Addendum 1
Solicitation 25-99633
Leif Erickson Park Stage Rehabilitation

This addendum serves to notify all bidders of the following changes to the solicitation documents:

Project: Leif Erickson Park Stage Structural Review

Bid Item #1

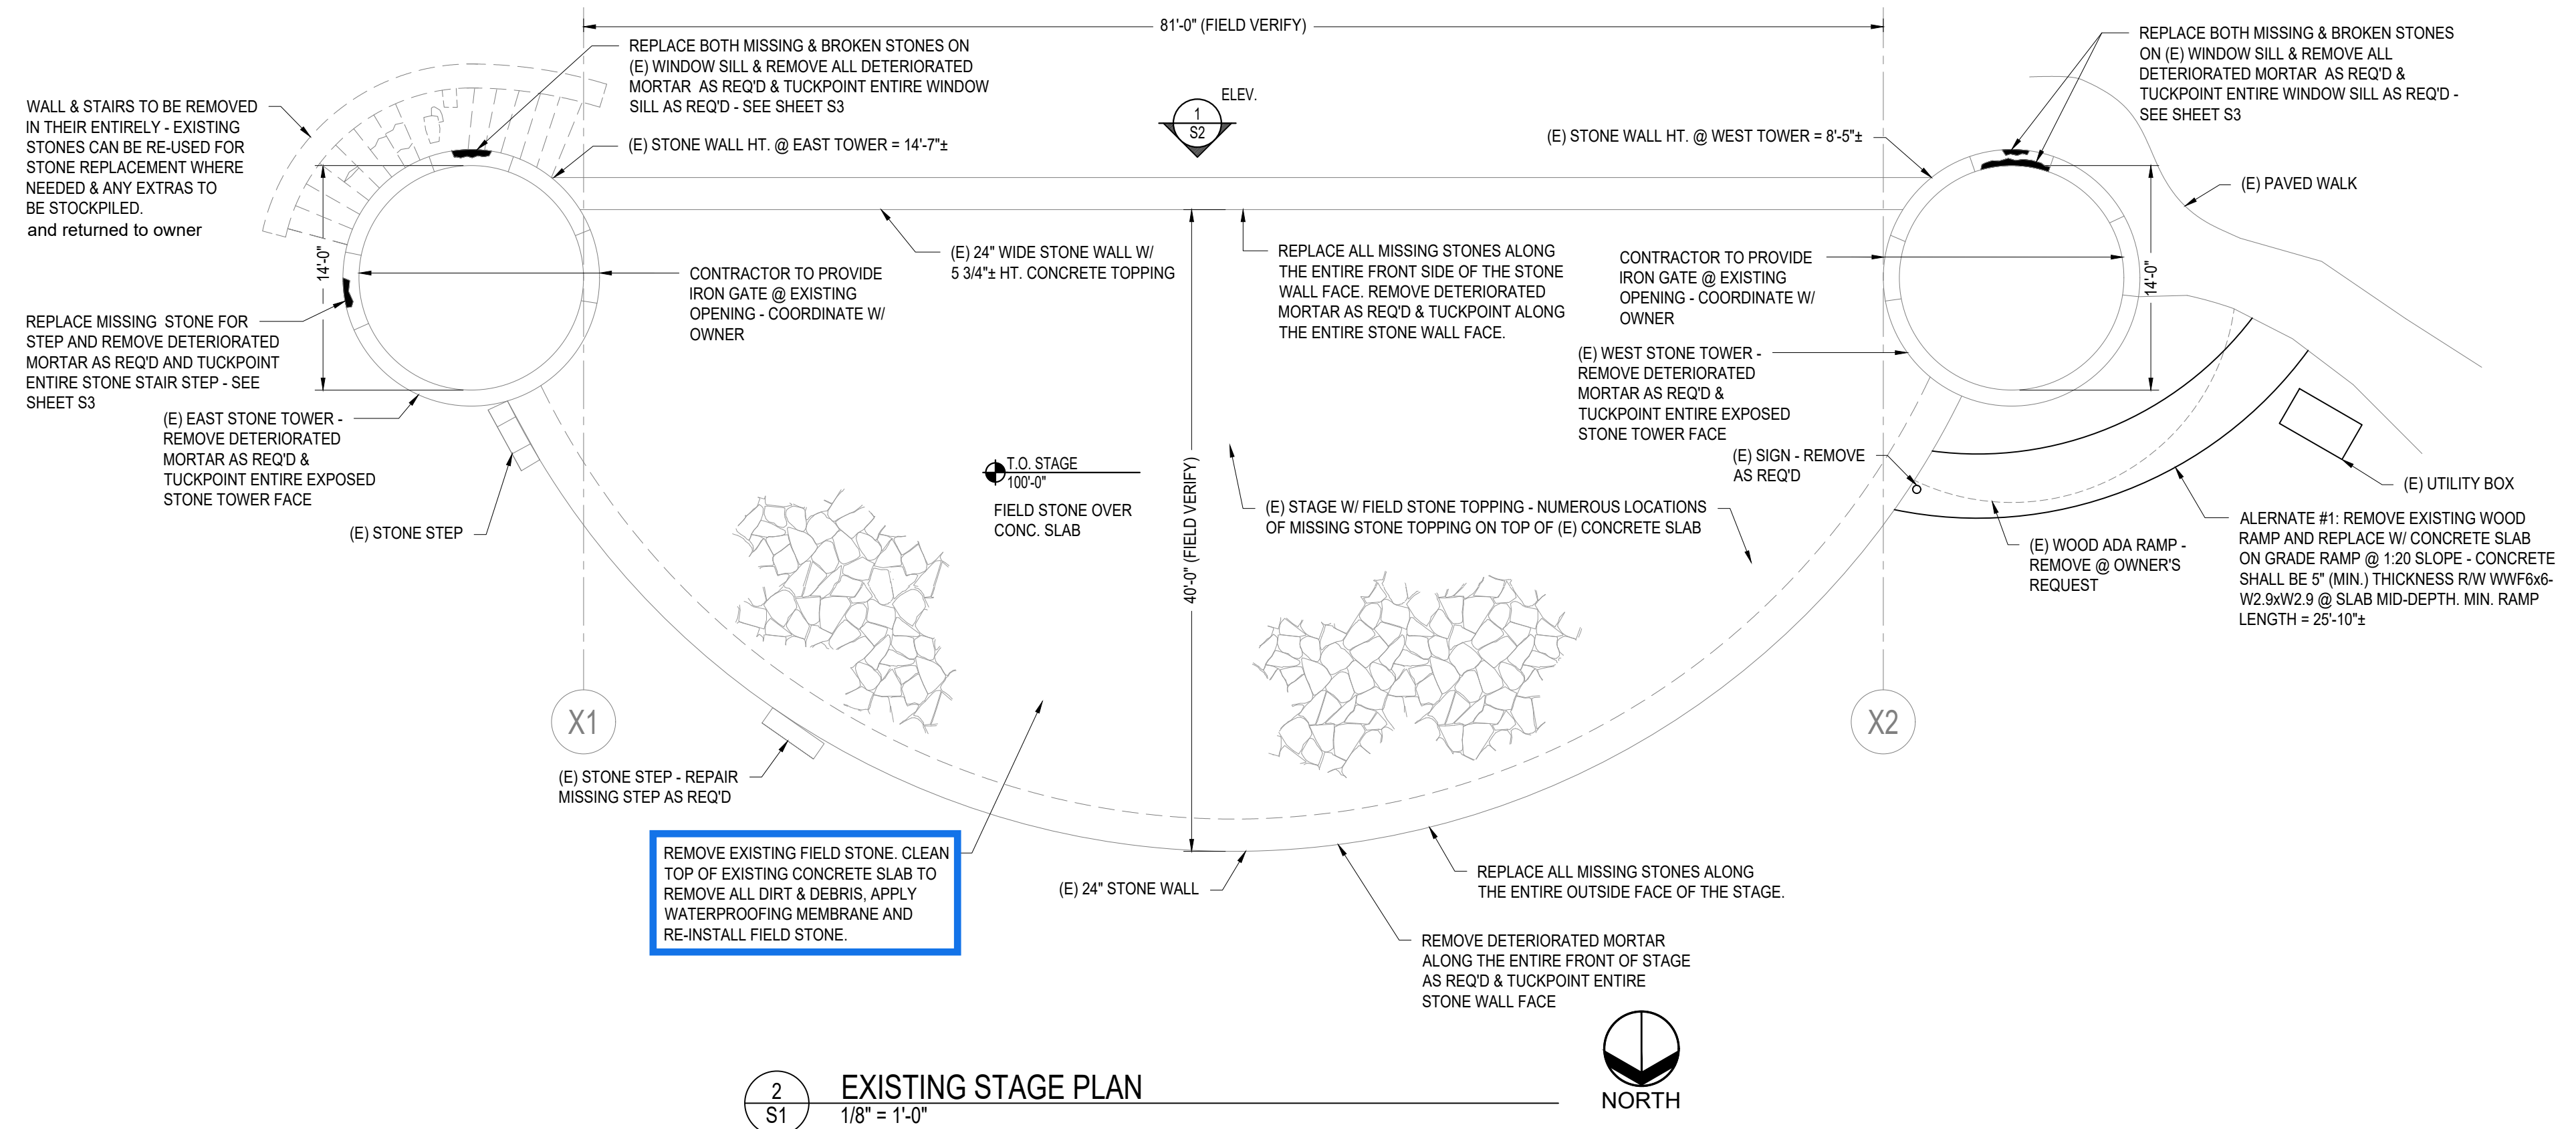
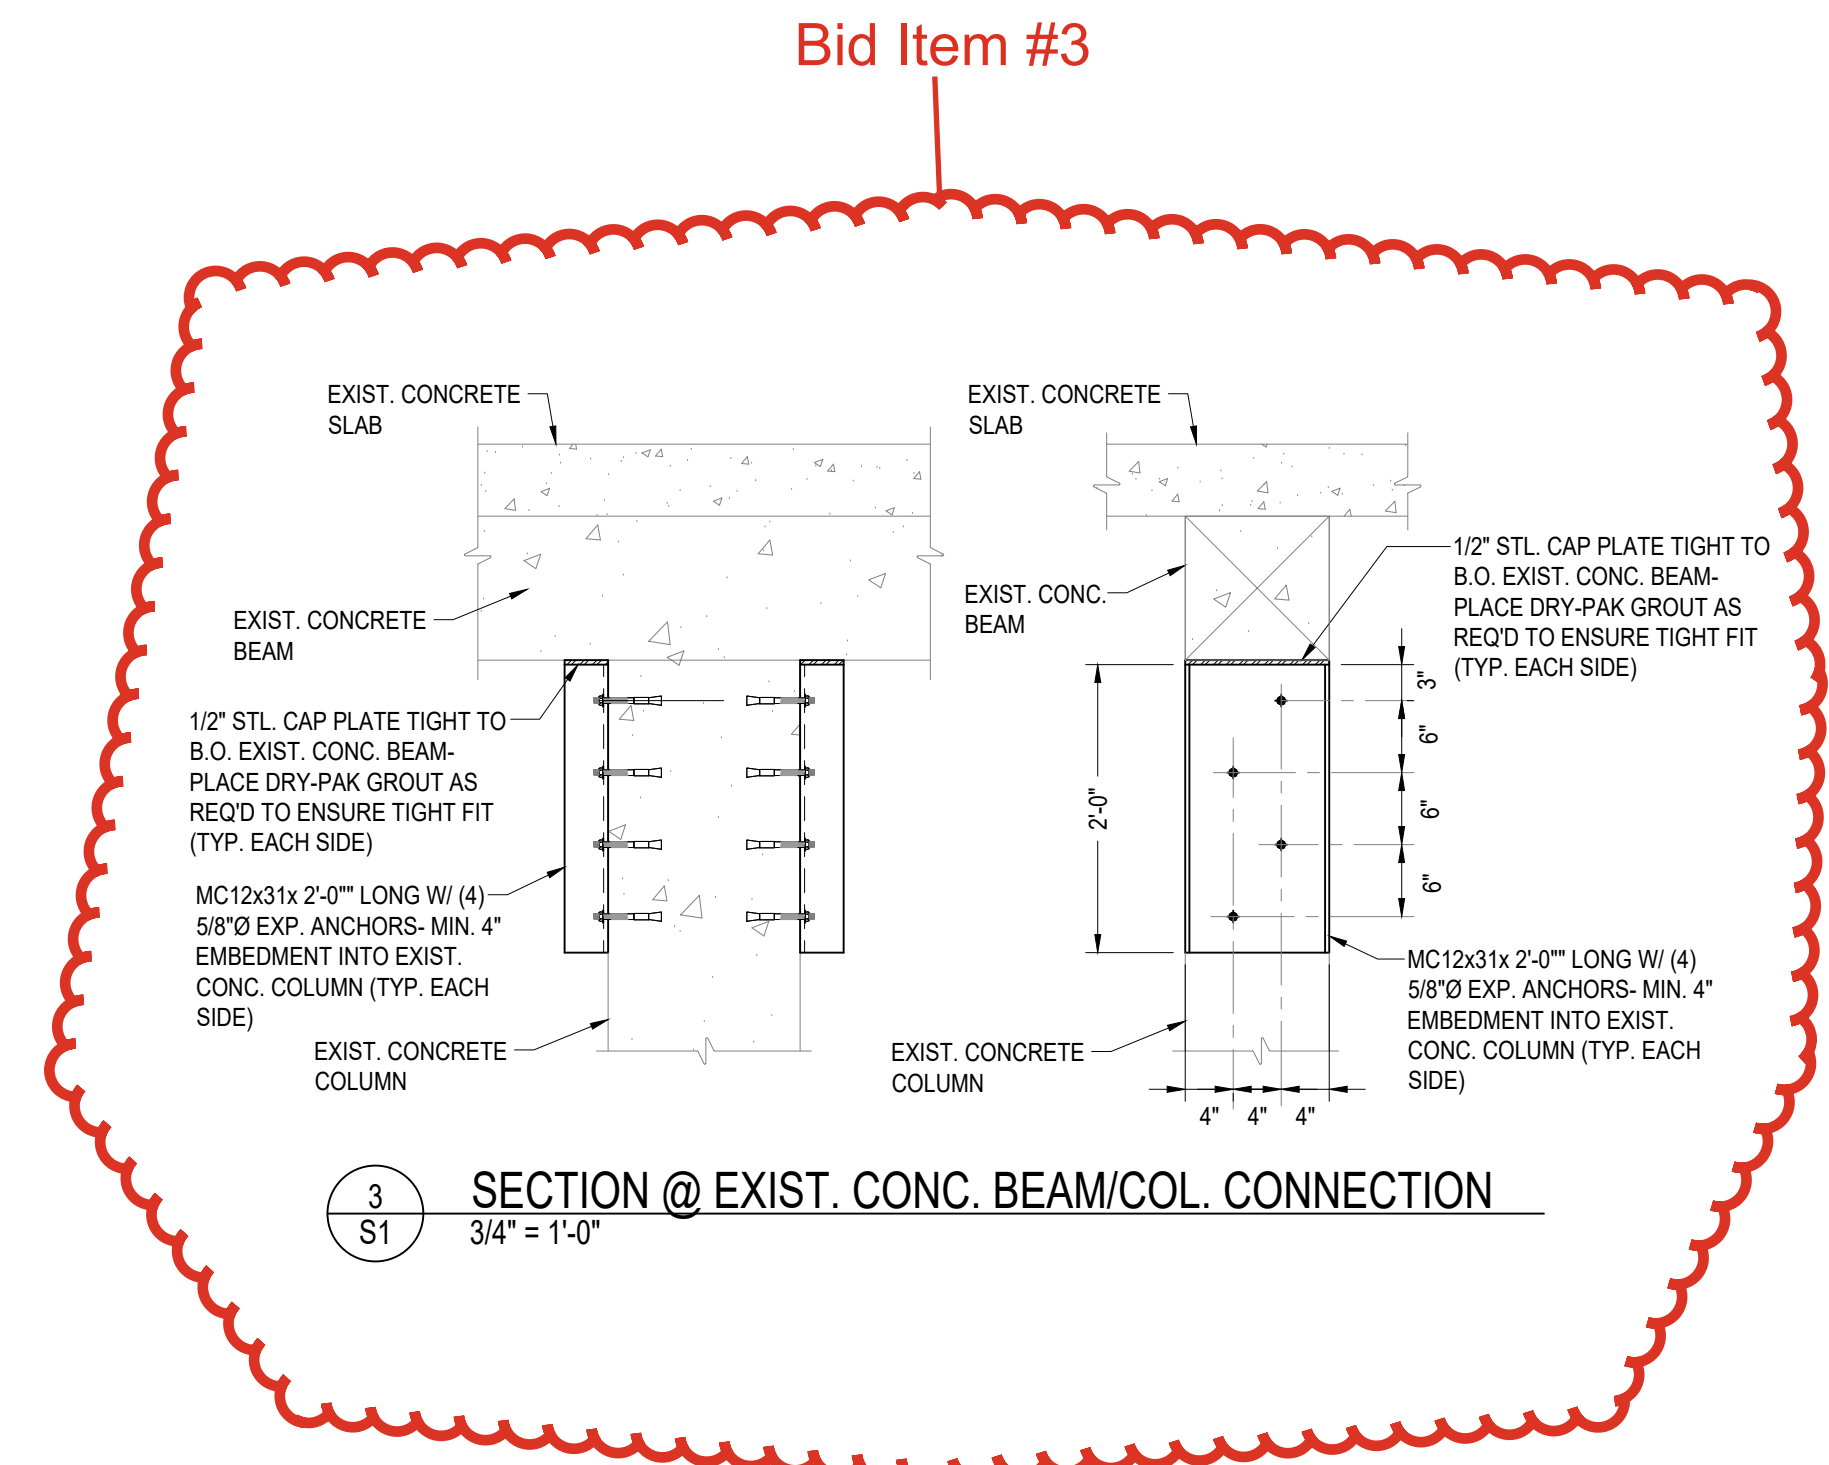
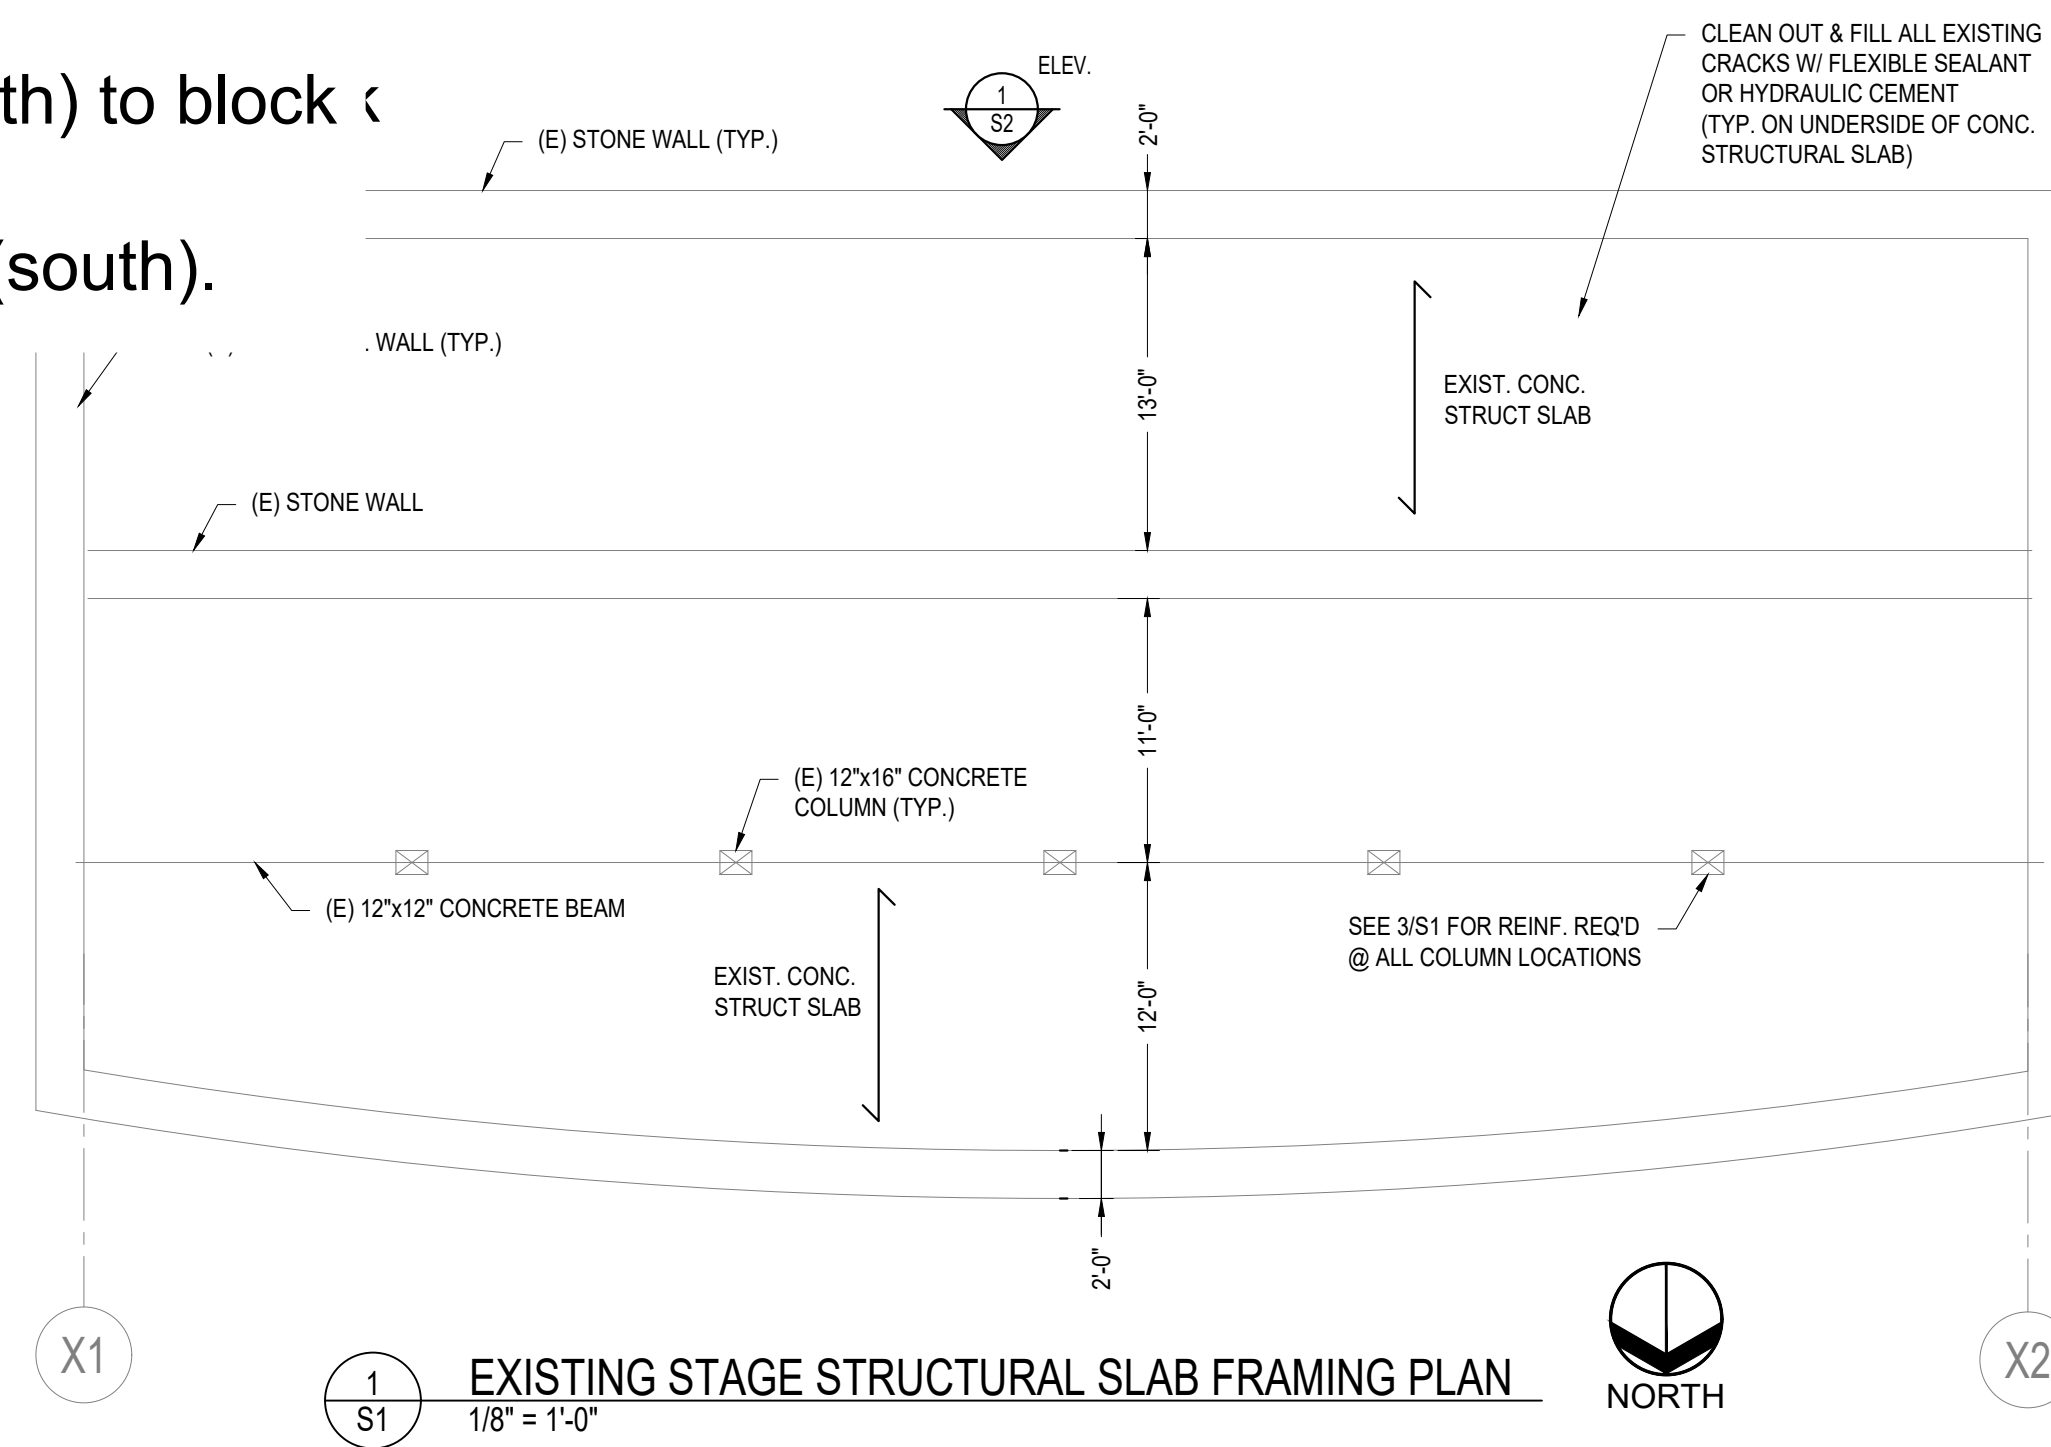
- 1. Tuck point and replace missing stones for entire structure
- 2. Remove wall and stairs on East tower
- 3. Install CMU on back side of stage wall (south) to block under stage opening.

Alt.#1 Install door on back side of stage wall (south).

SECTION @ EXIST. CONC. BEAM/COL. CONNECTION

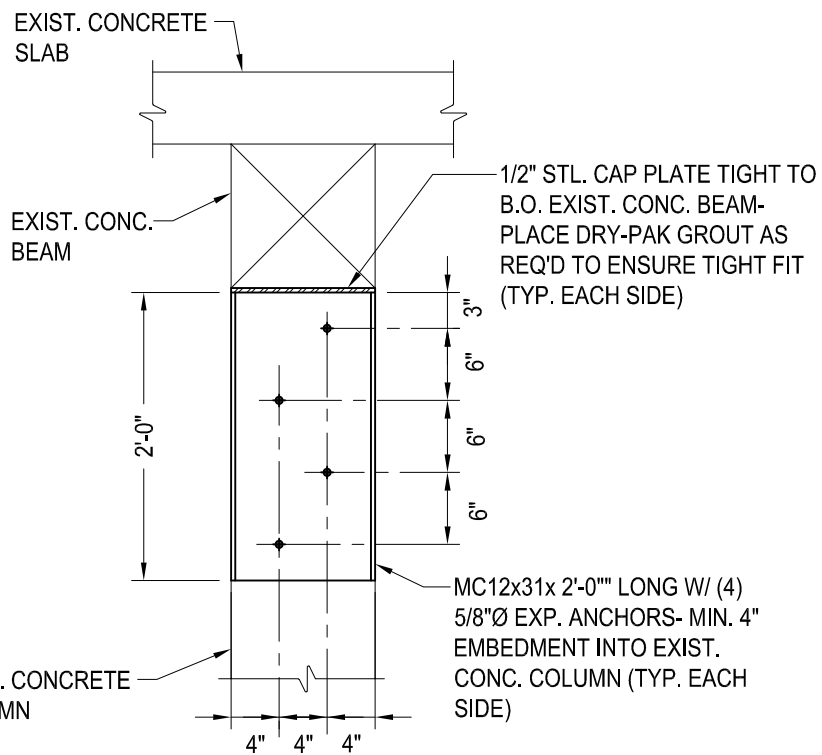
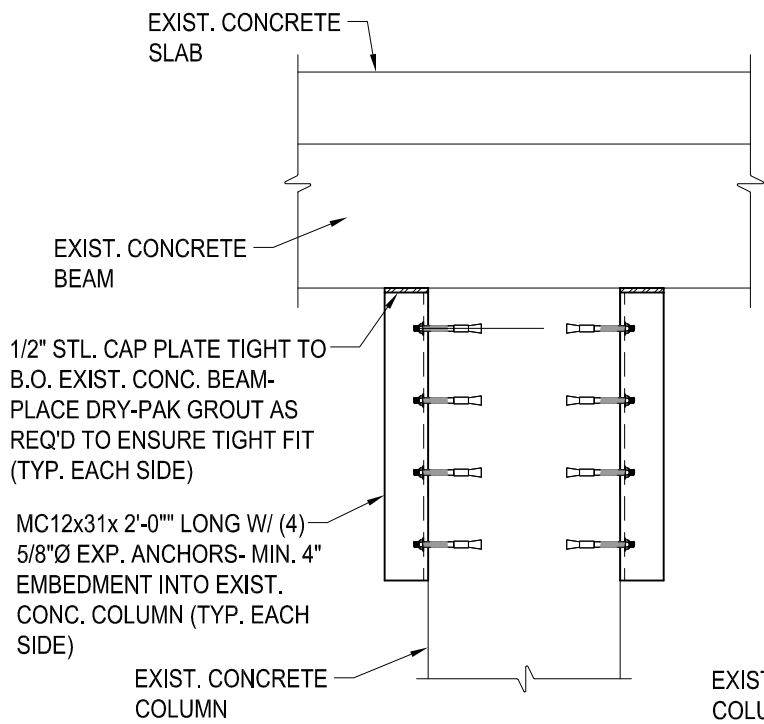
- B) We noted one structural concern with the existing stage floor framing system. Vertical cracks were evident where the concrete beams bear on the concrete columns, the width of which vary on each concrete beam. The cracks are due to shear forces being exerted at the ends of the concrete beams. The existing concrete beam reinforcing size and quantity are not known. The existing cracks are currently filled with foam insulation.

1. Reinforcing of all the existing concrete beam to column connections needs to be performed. See the following pages for a reinforcing section. Temporary shoring posts should be placed below the existing concrete beams on each side of the existing concrete column locations until the reinforcing work can be completed. Place the shoring posts within 12" of the concrete columns. Temporary shoring post bases can be placed on 12" concrete masonry blocks placed on top of the existing sand base.
